Office Action Summary

10/679,758

DETAILED ACTION

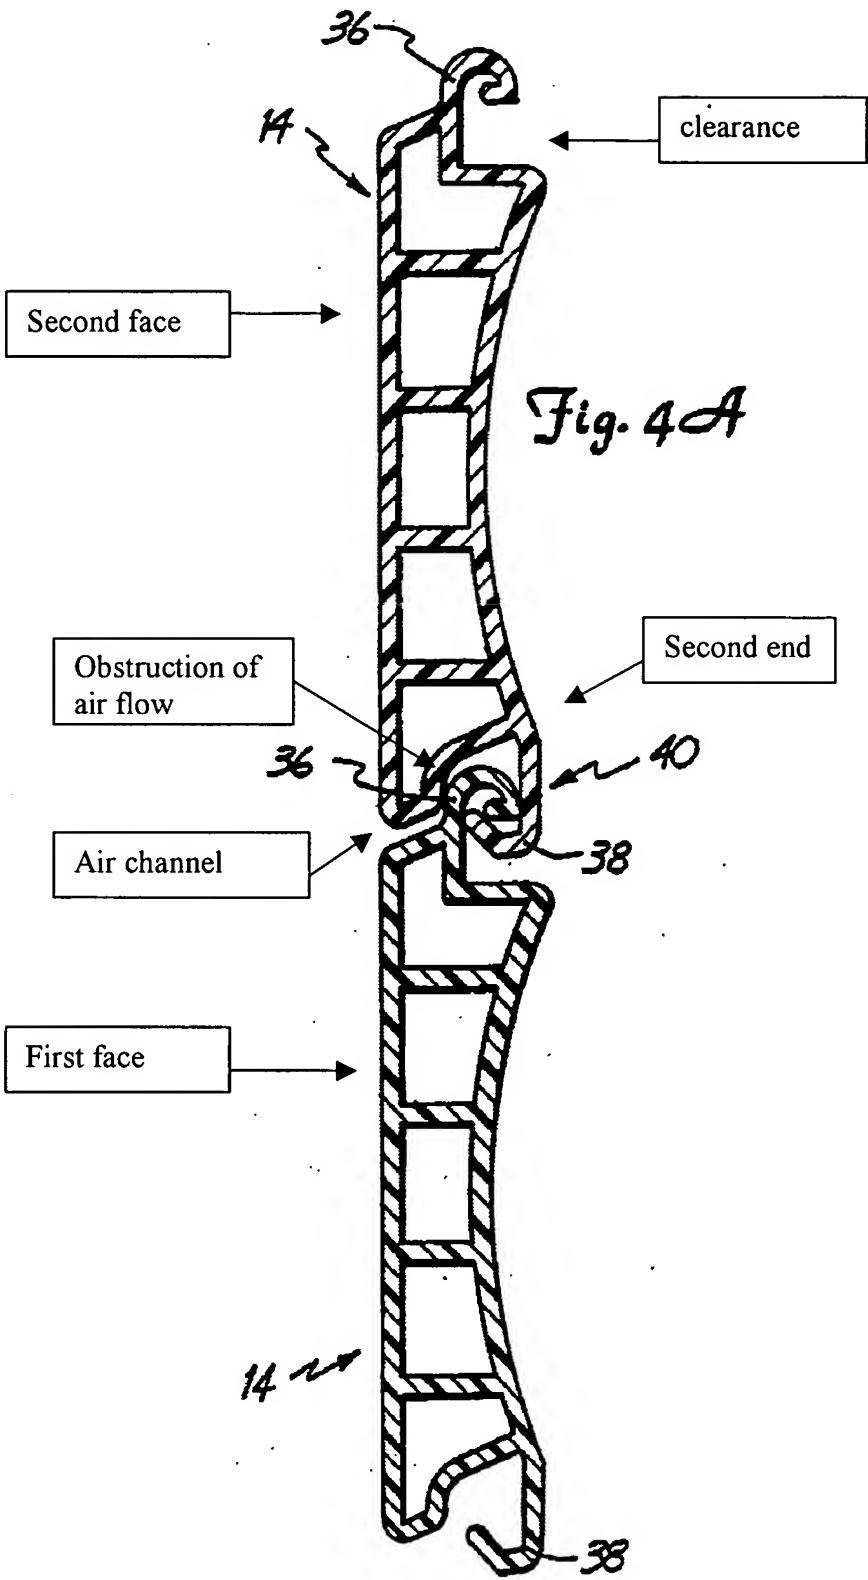
Regarding claim 1, Teigen et al. disclose a door (12) for use with a vehicle (10), the vehicle defining a load space (15) and having an access opening (16) communicating between the load space (15) and atmosphere, the door (12) comprising: a first panel (14) having an end (36), the end (36) having an arm and a protuberance connected to the arm (Fig. 4A), together the end, the arm, and the protuberance defining an arcuately shaped recess (Fig. 4A); and a second panel (14) having a hook (38), the hook being engageable (Fig. 4A) in the arcuately shaped recess to pivotably connect the first panel and the second panel, the hook having an arcuate shape corresponding to the arcuately shaped recess.

Regarding claim 2, Tiegen et al. disclose the door of claim 1, wherein the first panel has a first face (see below) and the second panel has a second face (see below), and wherein the second panel is pivotable relative to the first panel between a first orientation (Fig. 4B), in which the second face is substantially perpendicular to the first face (although Fig. 4B does not show the panel completely pivoted so that the second face is perpendicular to the first face, the panels are capable of such orientation), and a second orientation (Fig. 4A), in which the second face is substantially parallel to the first face.

Regarding claim 3, Tiegen et al. disclose the door of claim 2, wherein the second panel is fixedly connected to the first panel when the second panel is in the second orientation (Fig. 4A) and wherein the second panel is removeably connected to the first panel when the second panel is in the first orientation (when the panels are in the first orientation the hook would be able to fit through the clearance (see below) of the recess (36) and therefore would be removeably connected).

Regarding claim 6, Tiegen et al. disclose the door of claim 1, wherein the first panel and the second panel (14) define an air channel between the load space (15) and the atmosphere, the hook (38) matingly engaging the protuberance (36), and together, the protuberance and the hook obstructing air flow through the air channel (see below).
